Project: IEEE P802.15 Working Group for Wireless Personal Area Networks (WPANs)

Submission Title: Control Phase Length with MMS UWB Packet Configuration 1

Comment #266

DCN 15-25-0194-00-04ab

SOR – Time Offset to Poll

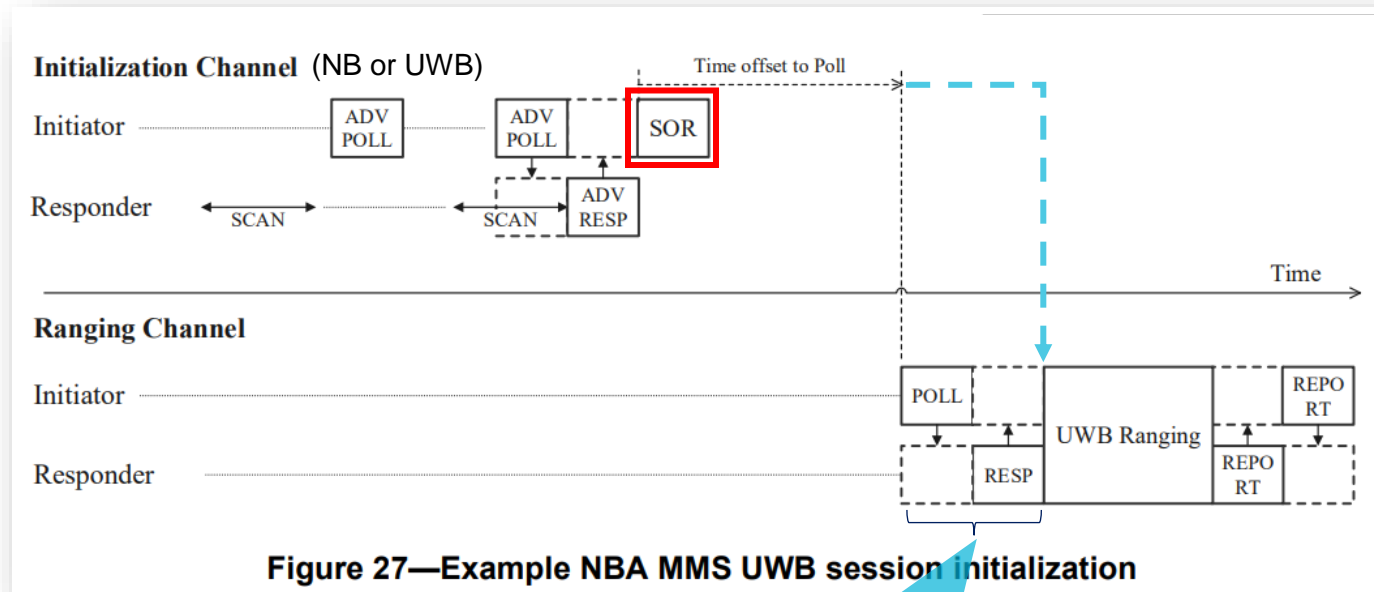
If *macMmsRcpPollNSlots* and *macMmsRcpRespNSlots* are set to zero, the SP0 frame is skipped and the SOR Time Offset points directly to the SYNC+SFD of the ranging packet

- Start of Ranging (SOR) Time offset to Poll indicates start of its SYNC + SFD
 - Poll can be NB or UWB
- Sending separate Poll and Response packets in Control phase is not always needed.
 - In case of UWBD mode, the SYNC+SFD fragments of MMS UWB Packet can be used for Poll and Response.
- If *macMmsRcpPollNSlots* and *macMmsRcpRespNSlots* are set to zero, Control phase becomes zero length and SOR points directly to the start of the ranging packet
 - More practical to use zero length than make control phase optional.

SOR – Management MAC Configuration – Control, Ranging and Report Phase

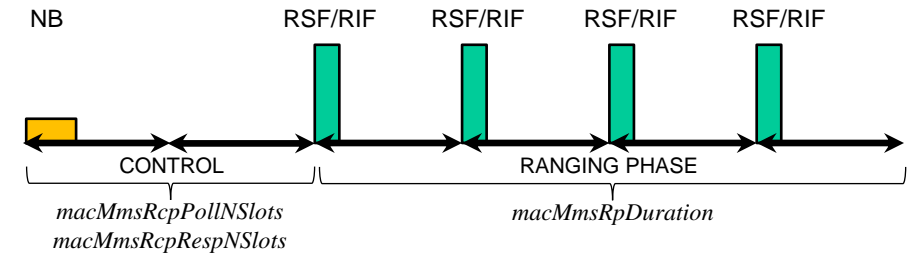
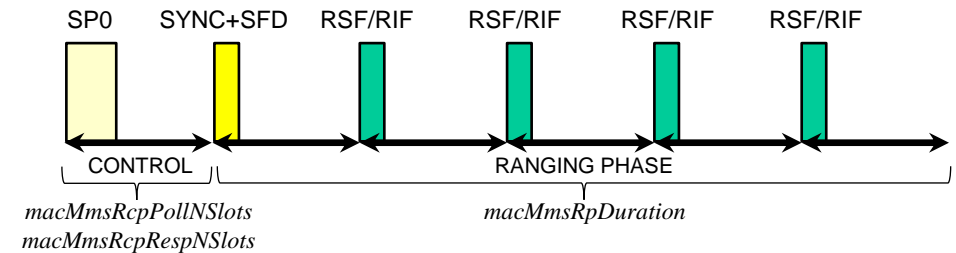
- Control, ranging, and report phase
 - Lengths configured with *macMms* parameters
 - NB poll typically 1.5 & 2 ms before the 1st fragment
 - For UWB SP0 (BASIC_PACKET) 2 ms total control phase length may also be preferred, shown here with 1 ms
 - Proposal: If *macMmsRcpPollNSlots* and *macMmsRcpRespNSlots* are set to zero, Control phase becomes zero.
 - If *macMmsRcpPollNSlots* and *macMmsRcpRespNSlots* are set to value 1 -15, SP0 is in use.

Interleaved mode ranging round – UWBD without SP0 and with SP0

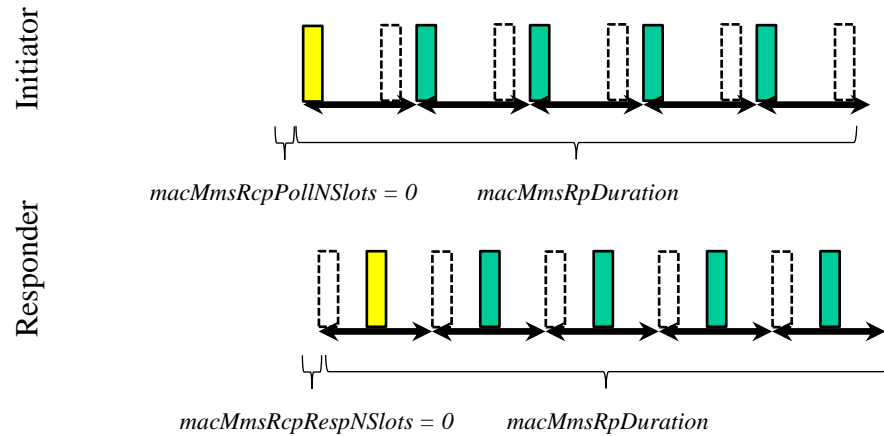
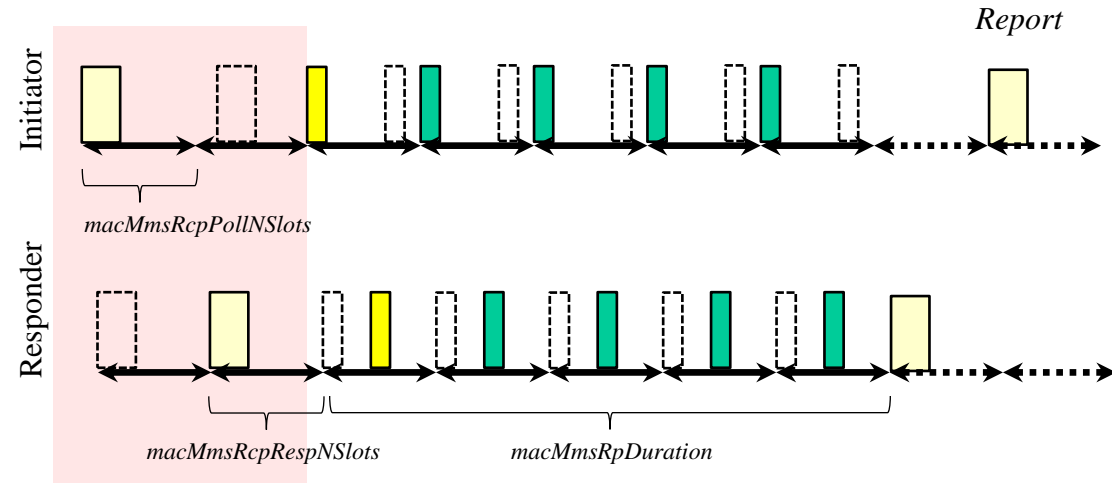
UWBD-MMS without SP0 ($macMmsRcpPoll/RespNSlots = 0$)

UWBD-MMS with SP0

Non-interleaved mode – UWBD-MMS without SP0

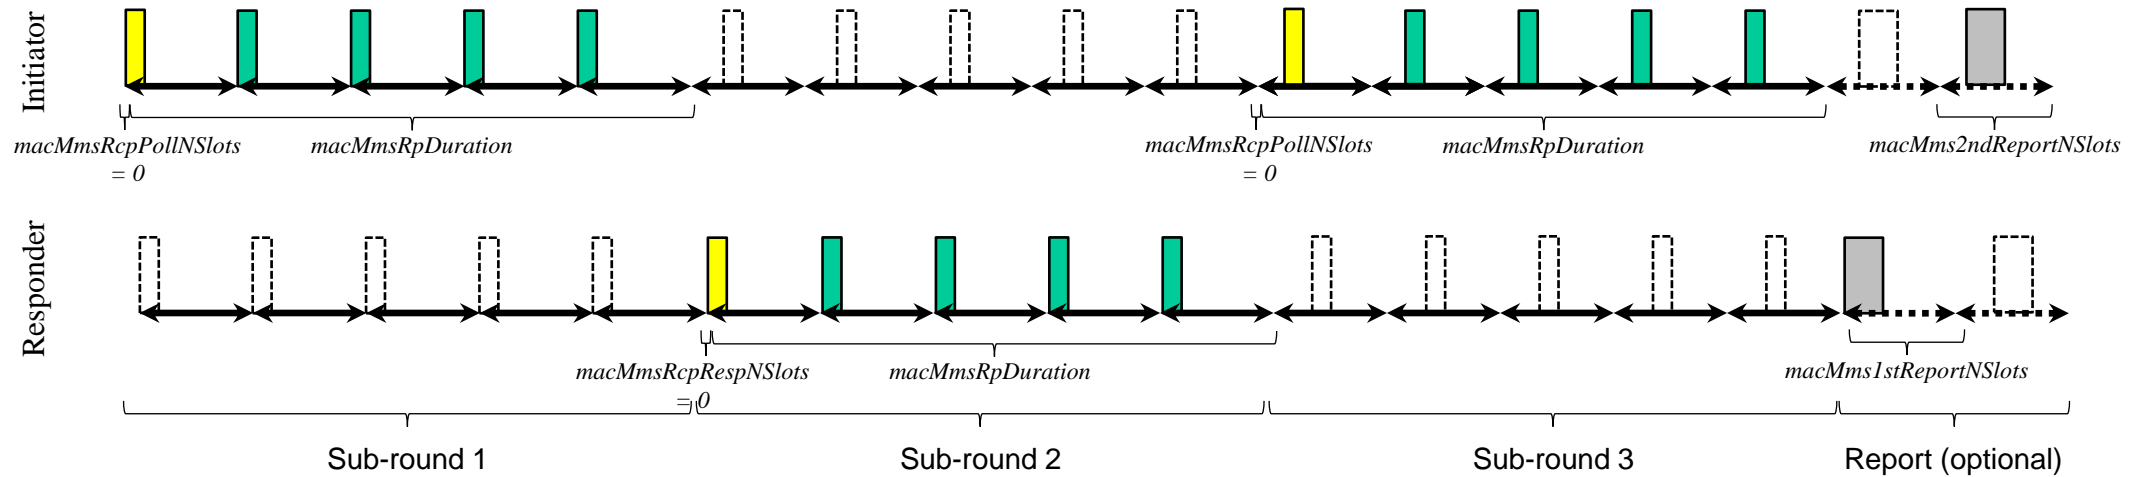
- Start of Ranging points to the start of SYNC + SFD
- In case of UWBD MMS, the MMS UWB packet has SYNC + SFD
- Poll and Response can be done with higher peak power level SYNC + SFD fragment
- Setting *macMmsRcpPollNSlots* and *macMmsRcpRespNSlots* to zero skips SP0 packets
- SP0 control packets can be used when needed (*Nslots* parameter value 1 – 15)
